**CUY-90-14.90**

**PID 77332/85531**

**PROJECT SCOPE**

**Innerbelt Bridge  
Construction Contract Group 1 (CCG1)**

Figure 14-1: E.9<sup>th</sup> Street over GCRTA Transverse Section

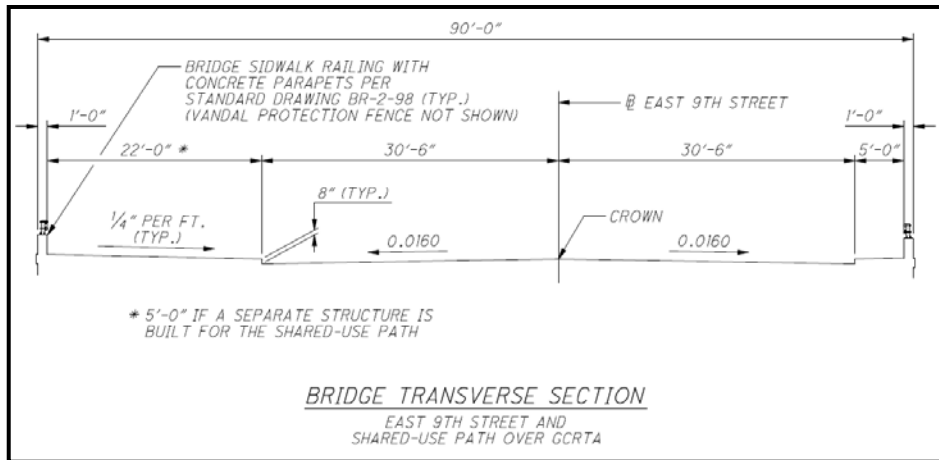
- A. This structure shall not have piers located between the existing retaining easement walls adjacent to the GCRTA tracks. This requirement is also shown in the No Build Zone drawings provided in the Appendix.

Comment [apg52]: Addendum No. 4
